Technical Memo No. 98 Thermaview[™] Sliding Window – 422 System Update

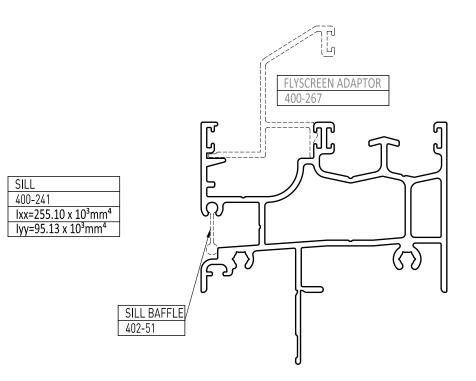
The Lidco Thermaview[™] Sliding Window (422 system) will shortly be revamped, to bring it in line with the current AS2047 standards.

The system will no longer have a double slide option in the 65mm width framing. Testing shows that a double sliding window has inferior water penetration ratings than that of a traditional Fixed-Slide configuration.

The Thermaview[™] Sliding Window with a fixed-slide configuration and a high performance sill threshold will enable it to achieve a far greater water rating.
